REMARKS/ARGUMENTS

Appl. No. 09/900,469
Amdt. dated September 17, 2004
Reply to Office action of June 23, 2004

FIG. 2

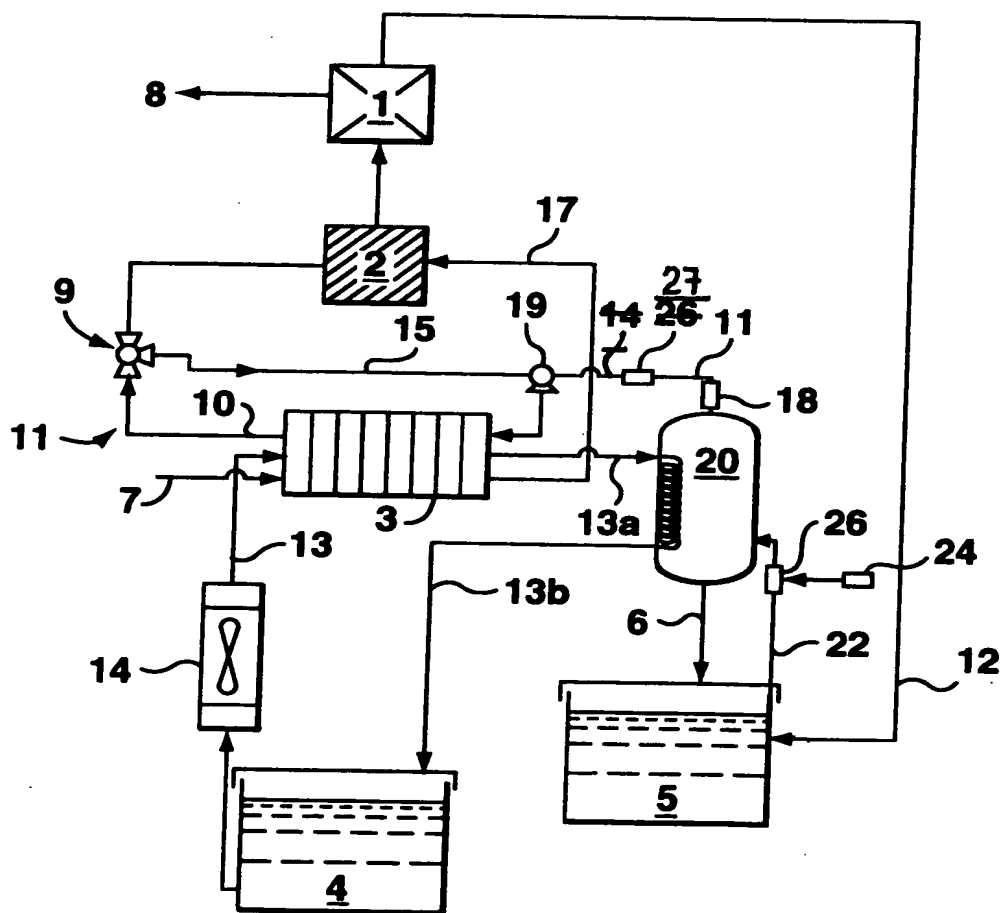
The Examiner further objected to the drawings under 37 C.F.R. 1.83(b)(4), on the grounds that the reference 14 has been used to denote two different elements. In response, the upper reference 14 in Figure 2 is being deleted.

The Examiner also correctly noted that the reference 26 had been used twice in Figure 2. The upper reference 26 is being changed to 27, and a corresponding amendment is being entered to the second line of paragraph 40, to refer to a "filter 27". Accordingly, it is submitted that this amendment brings the drawings into full compliance with the rules, and again no new matter has been added.

The attached sheet of drawings includes changes to Fig. 2. This sheet, which includes Fig. 2, replaces the original sheet including Fig. 2.
